UNITED STATES  
NUCLEAR REGULATORY COMMISSION  
WASHINGTON, D. C. 20555

BROWNS FERRY NUCLEAR PLANT, UNIT NO. 3

AMENDMENT TO FACILITY OPERATING LICENSE

Amendment No. 34  
License No. DPR-68

Residual Heat Removal System, Unit  
Cross Connections and Standby Coolant Supply

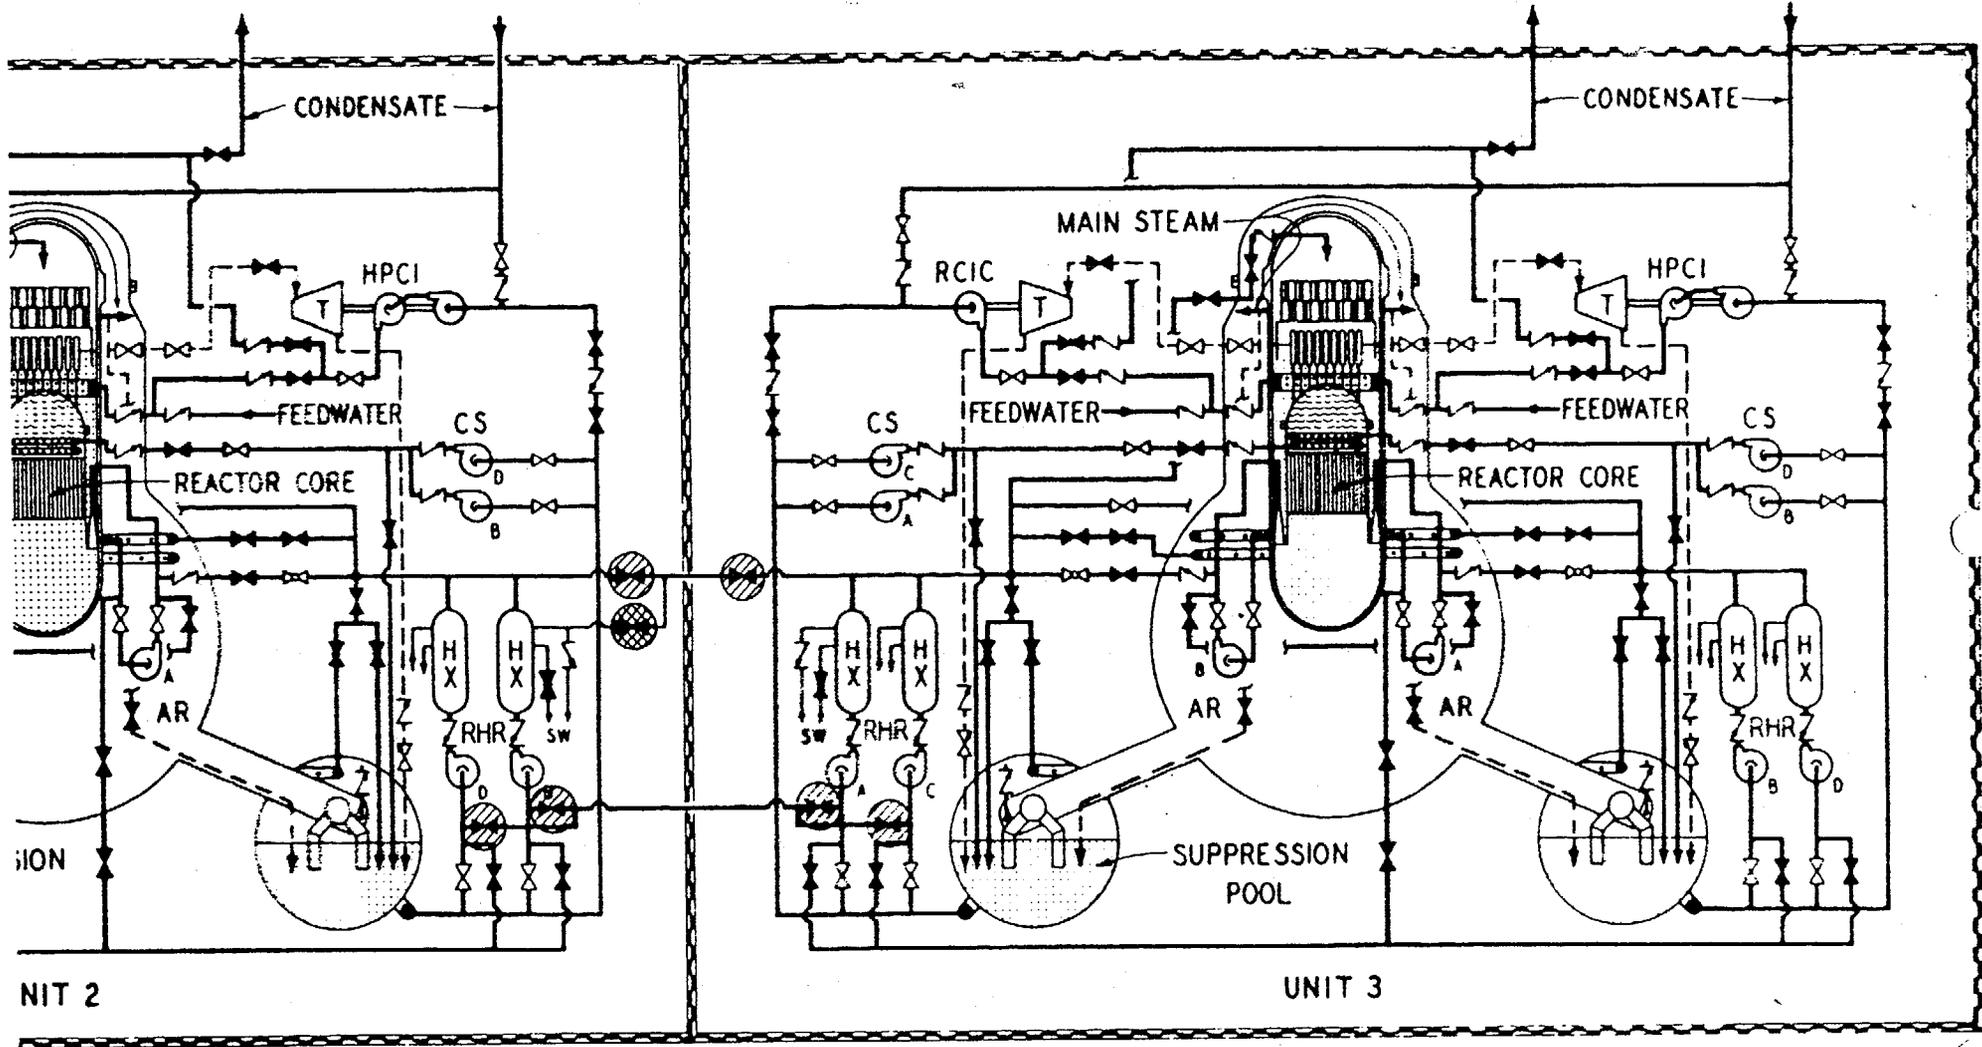
Each of the three Browns Ferry units has four residual heat removal (RHR) heat exchangers and four associated main system pumps. One of the RHR loops, consisting of two heat exchangers, two main system pumps in parallel, and associated piping, is located in one area of the reactor building. The other heat exchangers, pumps, and piping, forming a second loop, are located in another area of the reactor building to minimize the possibility of a single physical event causing the loss of the entire system. In addition, the pump suction and heat exchanger discharge lines of one loop in Unit 1 are cross-connected to the pump suction and heat exchanger discharge lines of one loop in Unit 2. Unit 2 and Unit 3 systems are cross-connected in a similar manner. Two normally closed isolation valves are provided in each heat exchanger discharge cross-connection and four normally closed isolation valves are provided in each suction cross-connection (one at each pump suction). This arrangement between Units 2 and 3 is shown in the attached figure; the cross-connection valves are those in the cross-hatched circles.

exchangers in each unit is adequate for all required functions. The cross-connections between the units in the RHR systems thus provide a third, redundant backup cooling system in case the pumps and heat exchangers in an RHR loop of an adjoining unit are both inoperable. As can be noted in the attached figure, the RHR heat exchangers and their associated pumps are in parallel with each other, so that a heat exchanger can be used even if the other heat exchanger in the loop is out of operation.

There is one other backup crosstie connection pertinent to this evaluation. On the service water outlet from the 1D RHR heat exchanger in Unit 1 and on the service water outlet from the 2B RHR heat exchanger in Unit 2, there is a connection to the primary system crosstie between the units. The connection from the 2B heat exchanger is shown in the attached figure. If all primary coolant and suppression pool water and condensate were lost, this cross-connection would permit the pair of B service water pumps to supply raw river water to the reactor core of Unit 2 or 3 (after the pressure approaches 50 psig) or to supply river water to the respective suppression chambers. Thus, the RHR service water in the B loop in Unit 2 is an emergency back-up supply of cooling water to Unit 3. Because of this function, the present Technical Specifications for Unit No. 3 only permit the unit to be operated for 30 days if one of the B1 or B2 RHRSW pumps is inoperable and require shutdown of the unit if the service water to the Unit No. 2 2B RHR heat exchanger is lost. TVA has requested that the present Technical Specifications for Unit No. 3 be amended to permit Unit No. 3 to be

To perform the required heat exchanger maintenance, both the RHR and RHRSW lines must be isolated. Isolation of the RHRSW line to the 2B heat exchanger isolates the standby coolant supply (RHRSW supply) from Unit 2 to Unit 3. Technical Specification 3.5.C.3 (Unit 3) presently states that "During power operation, both RHRSW pumps B1 and B2 normally or alternately assigned to the RHR heat exchanger header supplying the standby coolant supply connection must be operable." Although the proposed maintenance activity will not affect the operability of the 1B and 2B RHRSW pumps, it will isolate the RHR heat exchanger header supplying the standby coolant supply connection.

Although the present Technical Specifications as noted above permit operation for up to 10 days without the RHR primary coolant cross-flow capability, as described in the above "Discussion", Section 3.5.C.3 does not permit operation without the RHR service water cross-flow capability. The probability of needing-or using-the raw river water for backup cooling capability is far less than the possibility of using the RHR cross flow capability. If the raw service water were needed for backup coolant supply in Unit No. 3, the normal source would be the service water headers in Unit No. 3, rather than the cross-connection from Unit No. 2. If the RHR cross-flow connection can be out of service for 10 days - and our reevaluation concludes that this is reasonable and acceptable - it is logical and acceptable that the service water cross-connection can be out of service for 10 days also in view of the very low probability of ever needing this redundant backup source of raw river cooling water. We conclude that the proposed Technical Specification change to allow a 10 day outage time for the RHRSW cross-flow connection between units is acceptable and that the overall reduction in plant safety margin is insignificant.
